Planning Commission Meeting

January 14, 2020 6:00 PM

PLANNER'S REPORT

DATE: January 8, 2020
TO: Adrienne Senter
FROM: Michael Smith
RE: **Site Plan Review – 360 Lake Drive**

PAGE 2 OF 5
SITE PLAN FOR:
360 LAKE DRIVE
TAX PARCEL #14009400071058
LAND LOT: 94
DISTRICT: 14TH
FULTON COUNTY
GEORGIA
FIELD DATE: 09/18/18
PLAT DATE: 12/04/19
LOT: _____ BLOCK: _____
SUB: _____
AREA = 0.187 ACRES
JOB No. 18390SP

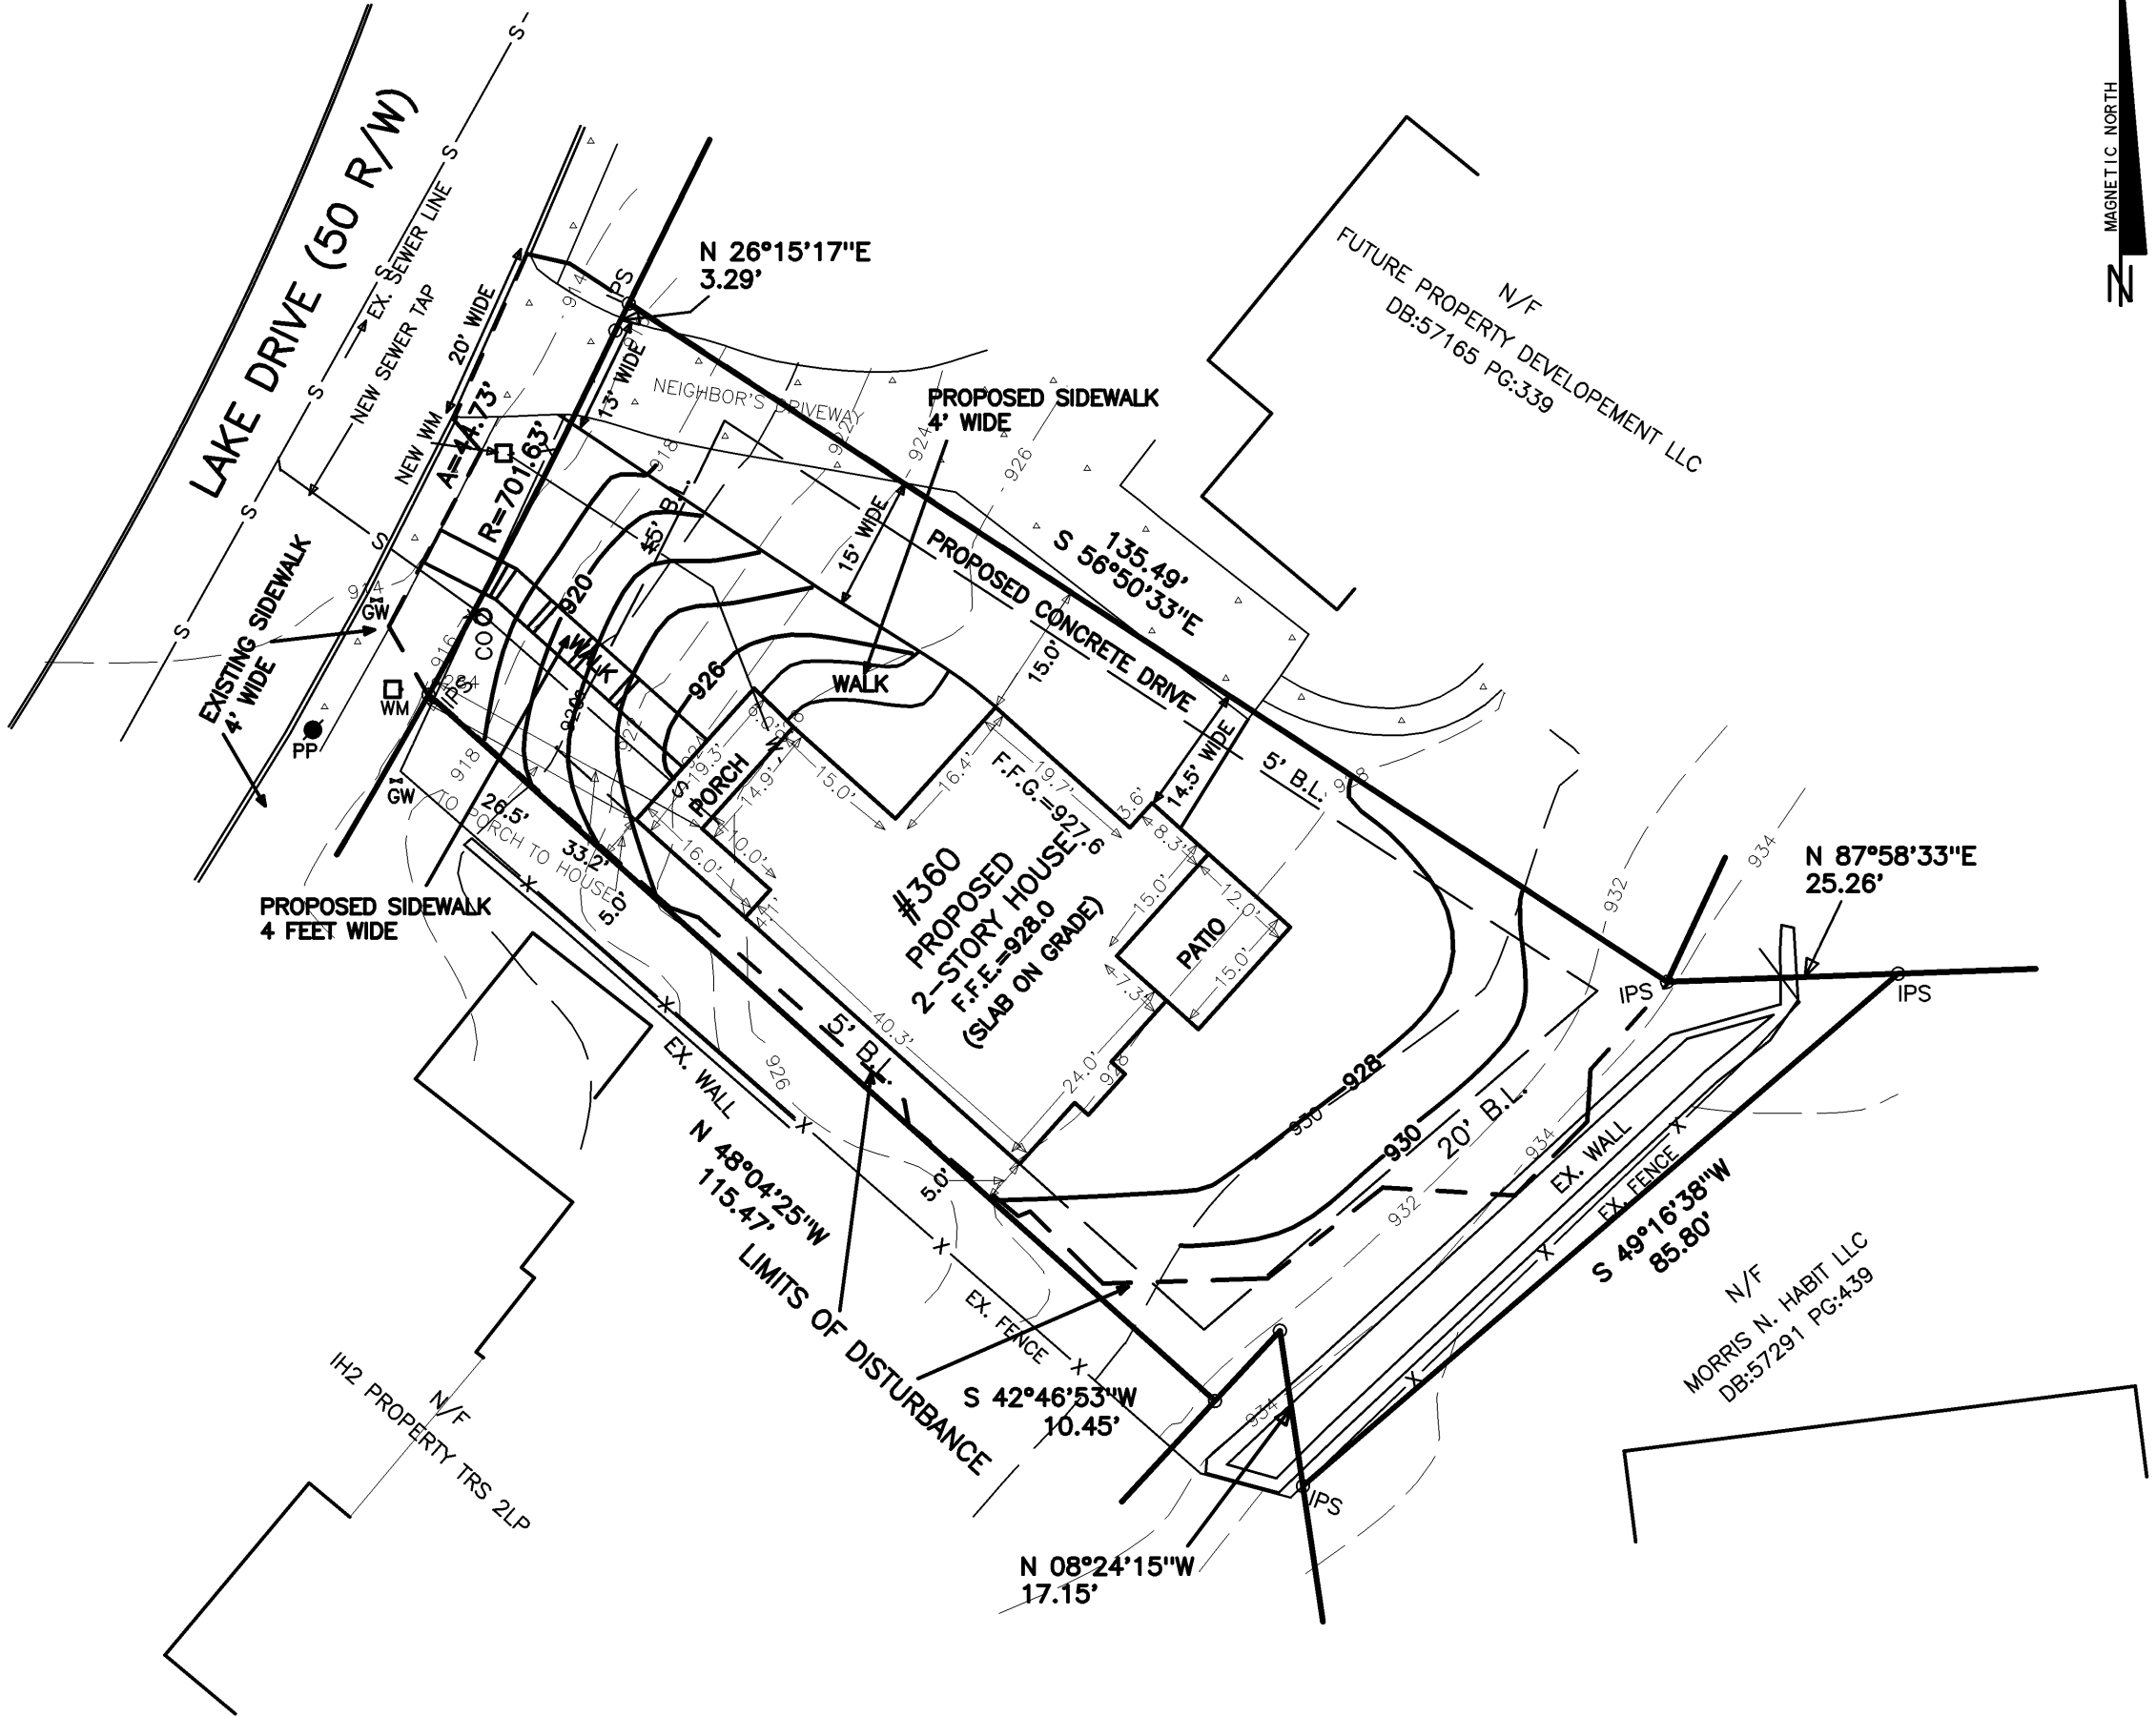
- ***The subject tract contains an existing wall and fence to the rear, outside the limits of disturbance, which are to be retained.***
- ***The plans indicate the dwelling will be 2-stories tall, and 28'-3 ½" high from grade.***
- ***The architectural drawings indicate the dwelling will be 2,529 sq. ft. in area.***
- ***Setback dimensions provided:***
 - ***Front setback is 26.5'***
 - ***Northeast side setback is 14.5'***
 - ***Southwest side setback is listed as 5'. However, the applicant has indicated the roof overhang as planned would extend 1' into the setback, which is not compliant. The applicant intends to submit a new site plan relocating the house one foot to the northeast, moving it beyond the setback.***
 - ***Rear Setback was not provided but is well beyond the minimum 20' setback.***

- *The plans include a walkway extending from the porch to the sidewalk.*
 - *The applicant should provide general design cross section characteristics for the sidewalk, driveway, and walkway.*

- c. The locations, area and number of proposed parking spaces.
- *A 15' wide driveway will provide access to an attached rear 2 car garage.*
- d. Existing and proposed grades at an interval of five feet or less.

- *Location and size of existing trees, trees to save and trees to remove are provided. Four trees are to be saved, and 11 trees are to be removed. One tree to be removed, a 31" oak, is a landmark tree. The removal of landmark trees must comply with the City's Tree Ordinance (see below).*

Based on the resolution of any items the Planning Commission may deem necessary, approval of the site plan is recommended conditioned upon the applicant providing updated and compliant plans.

PAGE 4 OF 5
LANDSCAPE PLAN FOR:
360 LAKE DRIVE
TAX PARCEL #14009400071058
LAND LOT: 94
DISTRICT: 14TH
FULTON COUNTY
GEORGIA
FIELD DATE: 09/18/18
PLAT DATE: 12/04/19
LOT: _____ BLOCK: _____
SUB: _____
AREA = 0.187 ACRES
JOB No. 18390LP

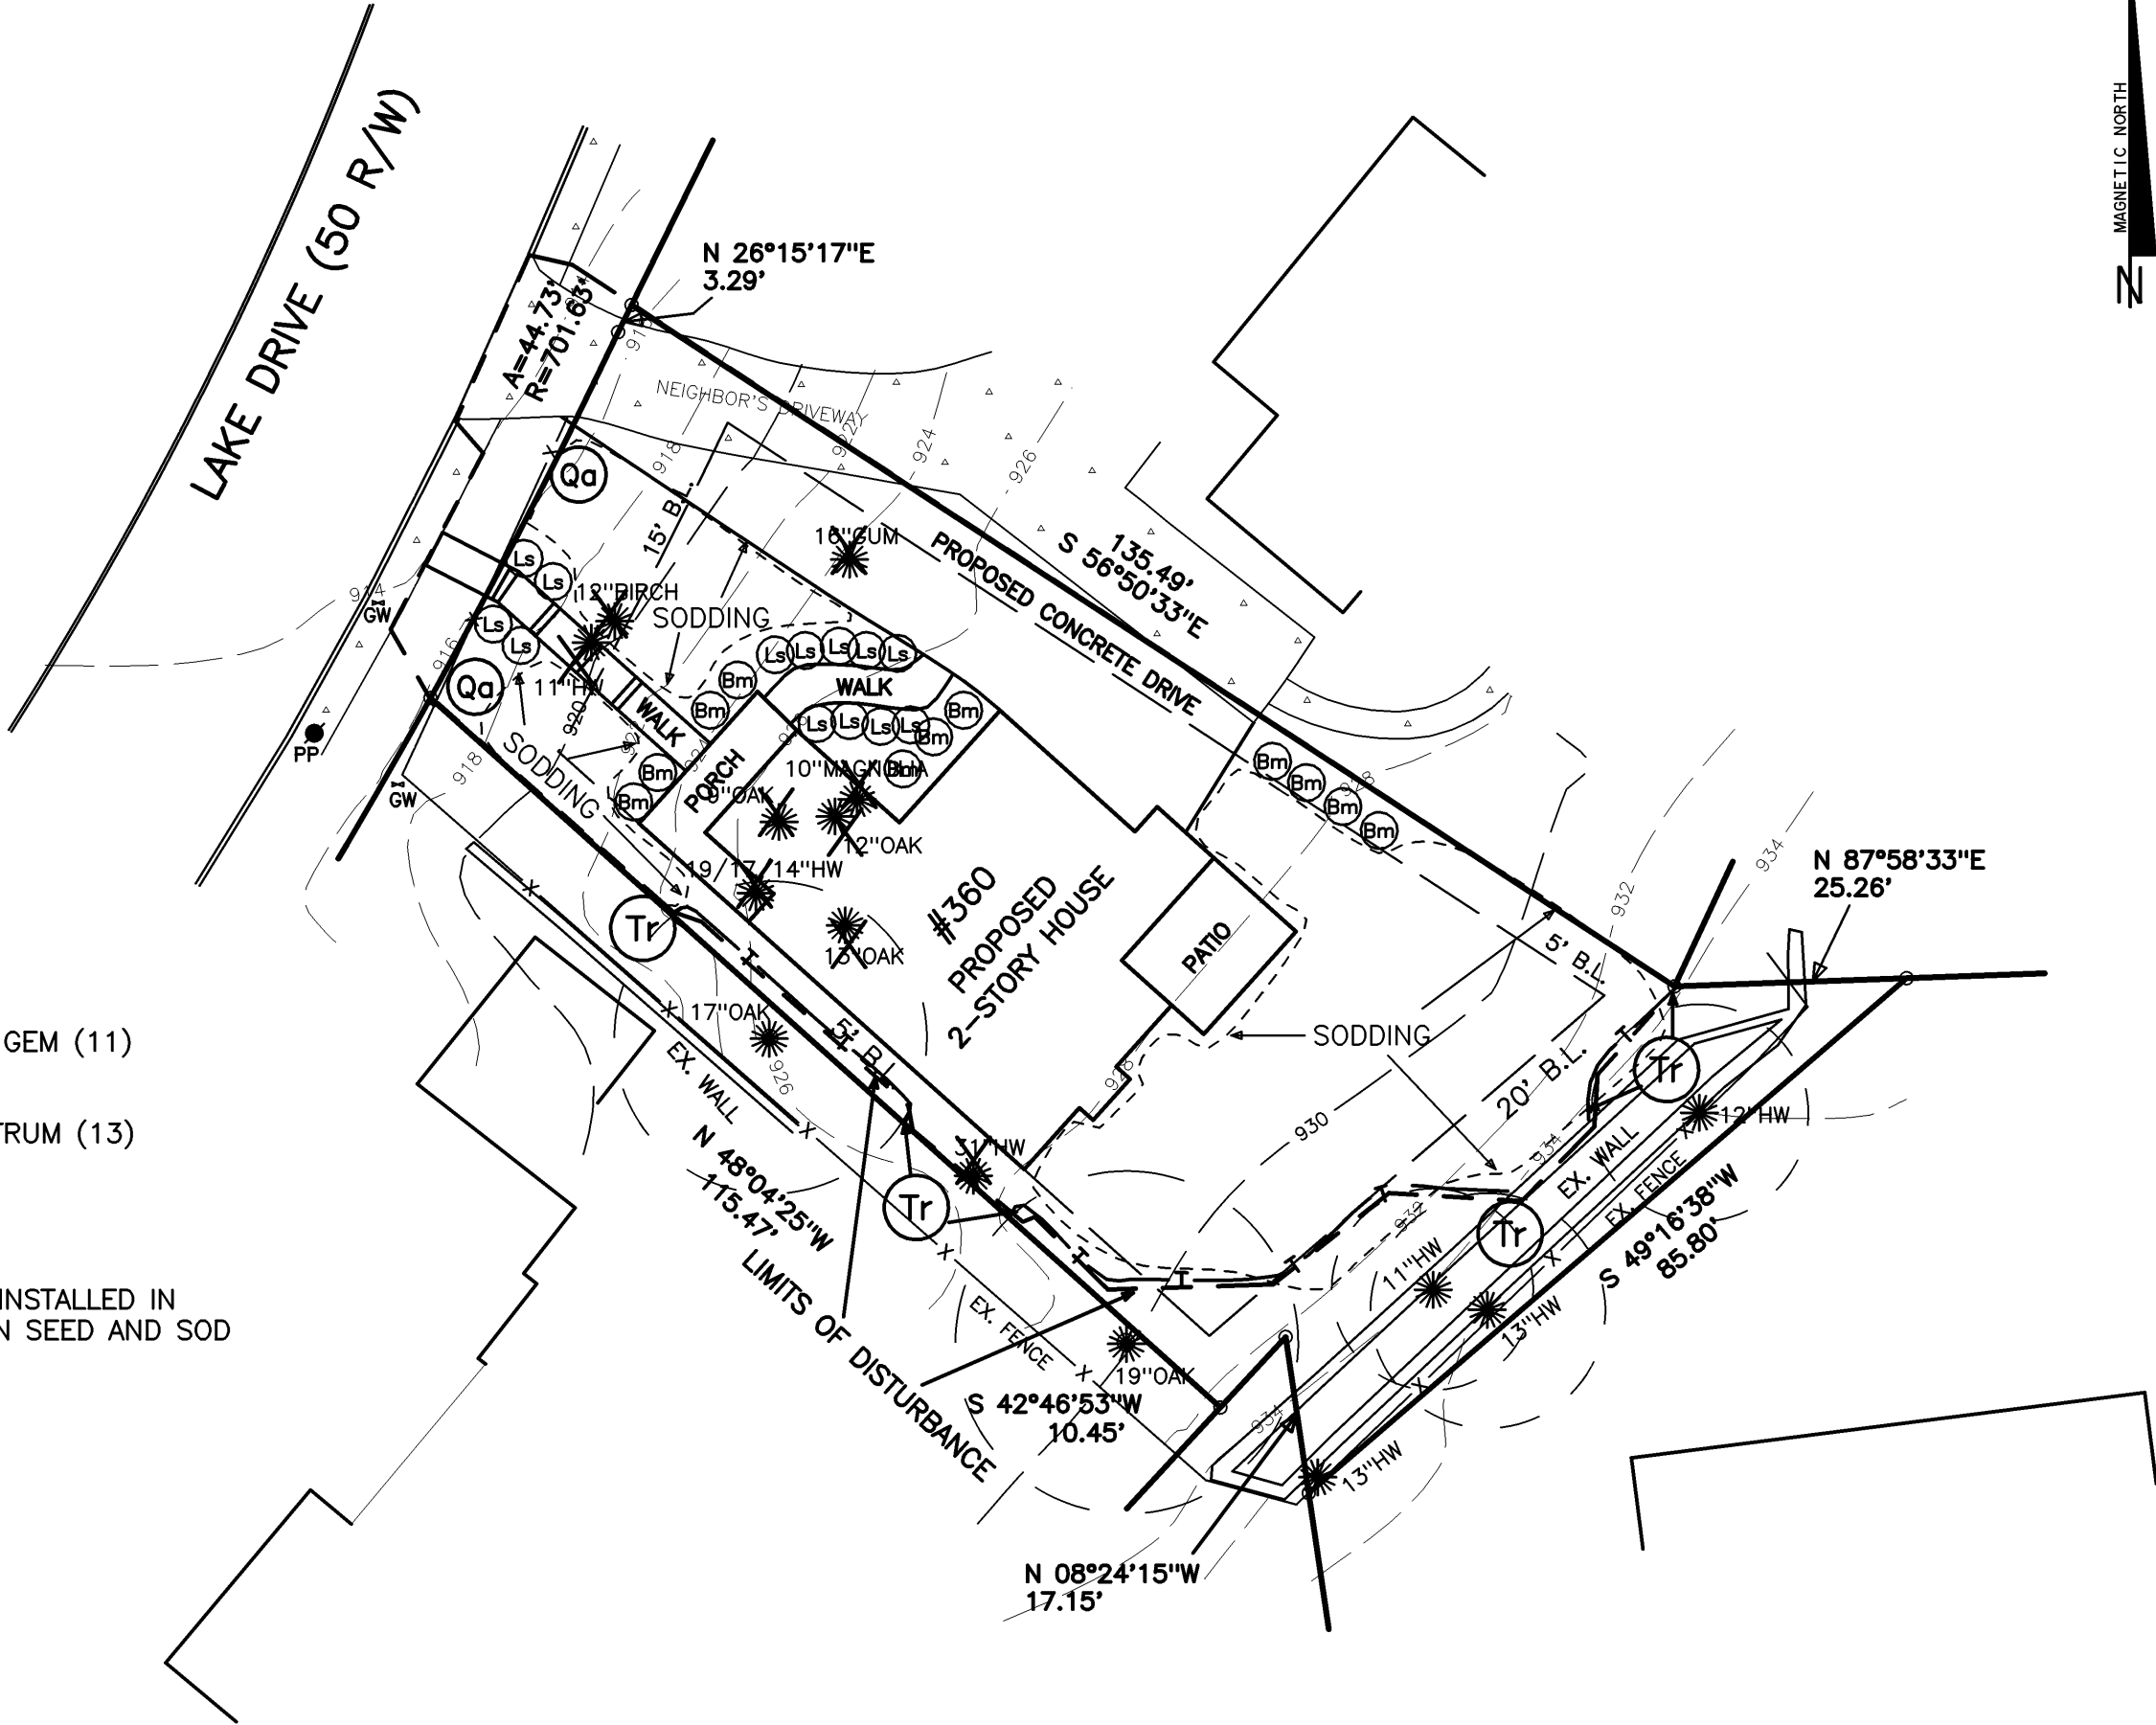
- *A landscape plan has been provided, indicating the addition of sodding, shrubs, and two new live oaks in the front yard.*
- g. The proposed general use and development of the site, including all recreational and open space areas, plazas and major landscape areas by function, and the general location and description of all proposed outdoor furniture (seating, lighting, telephones, etc.).
